# UNITED STATES PATENT AND TRADEMARK OFFICE

APPLICATION NO.	FILING DATE	FIRST NAMED INVENTOR	ATTORNEY DOCKET NO.	CONFIRMATION NO.
10/629,942	07/29/2003	Mustafa Michael Pinarbasi	HSJ920030061US1	1930

**Office Action Summary**

## **DETAILED ACTION**

**Taniyama et al Fig. 10D**  
(showing region of detail)

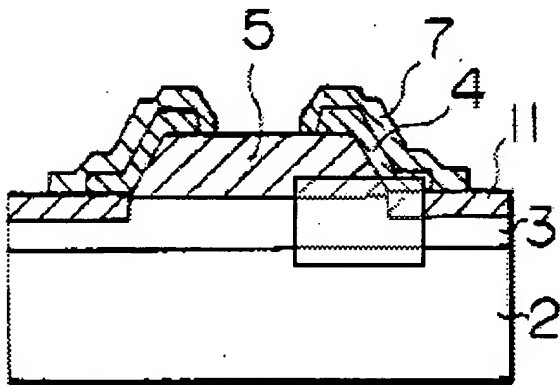
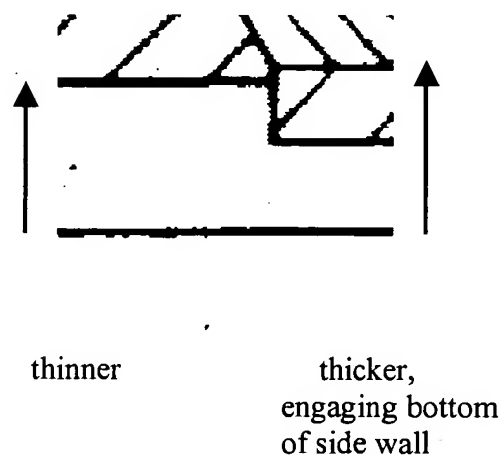
As recited in claims 1, 4 and 6, Taniyama et al show a magnetic read head (see Fig. 10D) that has a head surface comprising a read sensor 5 that forms a portion of said head surface and has first and second side walls which extend into the read head from said head surface; nonmagnetic electrically insulative first (including 3 and 11) and second 8 read gap layers wherein the first read gap layer includes a read gap material layer 3 and first and second refill gap layers 11; the read gap material layer having first and second depressions (in which refill

layers 11 are located) which extend laterally from the first and second side walls respectively of the sensor; the first and second refill gap 11 layers being disposed in the first and second depressions and engaging a bottom portion of the first side wall and engaging a bottom portion of the second side wall (see Fig. 10D, annotated detail) respectively; the first read gap layer having first and second portions which extend laterally from the first and second side walls of the sensor and a third portion which engages a bottom surface of the sensor and is located between said first and second portions; and a first lead layer 7 electrically connected to a top portion of the first side wall and a second lead layer 7 electrically connected to a top portion of the second side wall.

As recited in claims 3, 5 and 7, Taniyama et al show first and second hard bias layers 4 interfacing the first and second refill gap layers 11 respectively and the top portion of the first and second side walls respectively; and said first and second lead layers 7 interfacing the first and second hard bias layers 4 respectively.

reciting: “the first and second refill gap layers being disposed in the first and second depressions and engaging a bottom portion of the first side wall and engaging a bottom portion of the second side wall respectively; the first read gap layer having first and second portions which extend laterally from the first and second side walls of the sensor and a third portion which engages a bottom surface of the sensor and is located between said first and second portions; each of said first and second portions having a thickness which is greater than a thickness of said third portion;”. The Examiner notes that in col. 4, lines 58-61, Taniyama et al teach that “The combined thickness of the insulating film 11 and the lower gap film (lower insulating film) 3 in a region other than the track portion, of course, can be larger than the track portion.” Furthermore, this feature is shown in Fig. 10D of Taniyama et al. Thus, the independent claims remain anticipated, despite Applicant’s amendments.
